PROPOSED TECHNICAL SPECIFICATION CHANGE TSP-910003-0  
VIRGIL C. SUMMER NUCLEAR STATION

3/4.7.7 SNUBBERS

PROPOSED TECHNICAL SPECIFICATION CHANGE - TSP 910003-0  
VIRGIL C. SUMMER NUCLEAR STATION  
DESCRIPTION AND SAFETY EVALUATION

FIGURE 4.7-1 SAMPLING PLAN FOR SUNBBER FUNCTIONAL TEST

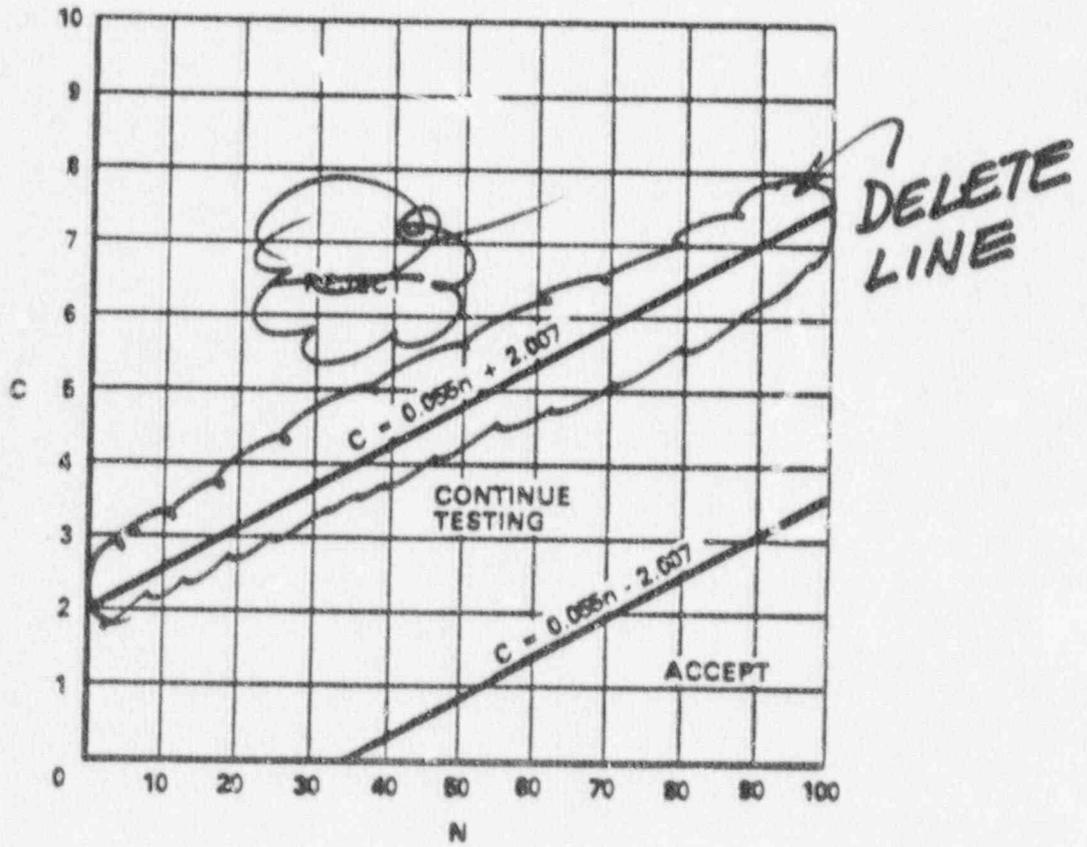
SCE&G proposes to modify the Virgil C. Summer Nuclear Station Technical Specifications (TS) to revise TS 4.7.7 and associated Bases 3/4.7.7 in accordance with GL 90-09; additionally, the REJECT line in figure 4.7-1 and all references to this line are deleted from the text. The proposed amendment changes the snubber visual inspection schedule of surveillance requirement 4.7.7 to the alternate visual inspection schedule specified by GL 90-09, and changes the associated Bases 3/4.7.7.

The Reject line, developed using Wald's Sequential Probability Ratio Plan, assumes that the sample is totally homogeneous, and that the failure in the total population is in the same ratio as the failures observed in a given sample. This is not correct when functionally testing snubbers in nuclear power stations. Snubbers can not be considered a homogeneous population, since the sampling for functional testing includes various configurations, different environmental conditions, different sizes, capacities and types of snubbers, and the sample is weighted to include more snubbers from severe service areas.

Deletion of the Reject line in Figure 4.7-1 does not contribute to any reduction in the margin of safety.

the "Accept" region testing of that type of snubber may be terminated. When the point plotted lies in the "Continue Testing" region, additional snubbers of that type shall be tested until the point falls in the "Accept" region ~~or the "Reject" region~~, or all the snubbers of that type have been tested.

- 1) functionally test 10 percent of a type of snubber with an additional 10 percent tested for each functional testing failure, or
- 2) functionally test a sample size and determine sample acceptance ~~and~~ ~~rejection~~ using Figure 4.7-1.
